# ADDENDUM NO. 03

**November 2, 2026**

**Franklin Central High School Health Sciences Pavilion**
**6215 S. Franklin Rd**
**Indianapolis, IN 46259**

**Subject:** Addendum No. 3 for Bidding Documents for the
**Franklin Township Community School Corporation**
**Franklin Central High School Health Sciences Pavilion**
**Indianapolis, Indiana**

Drawing No: **A001**

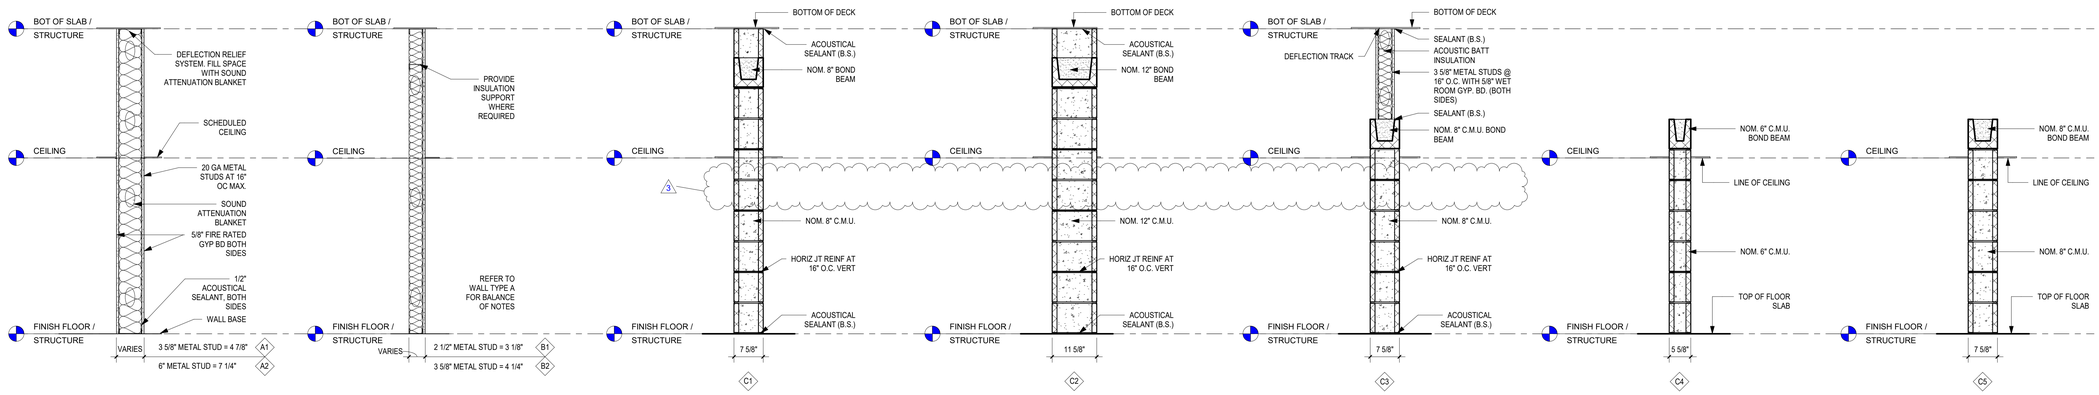
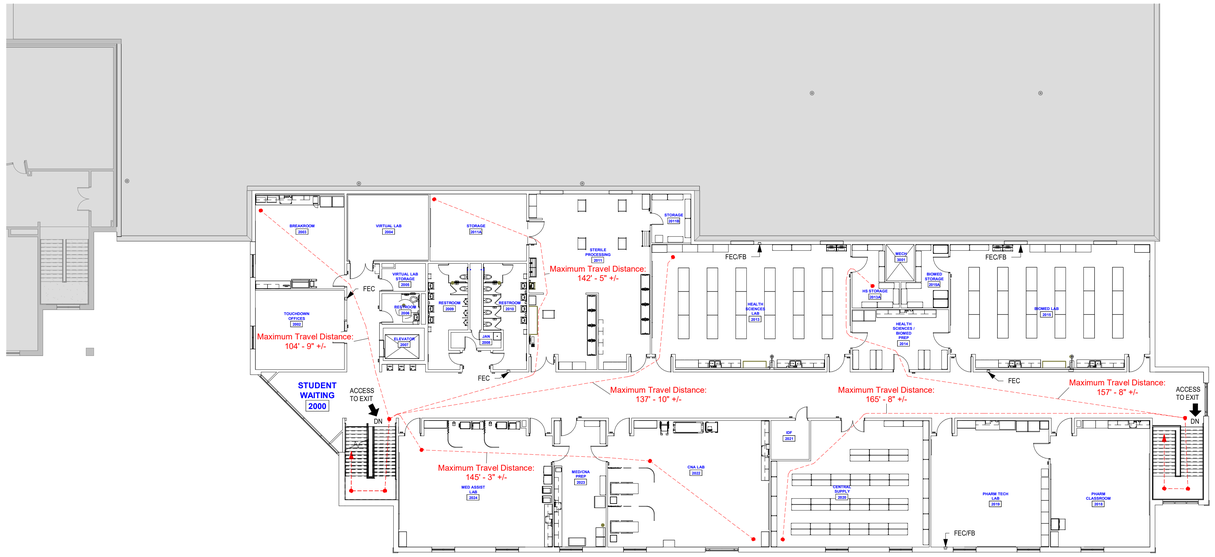
1) Sheet A001 – Walls C1, C2 and C3 – Change "Grout Cores Solid" to "See Structural Sheets for Grouting Requirements".
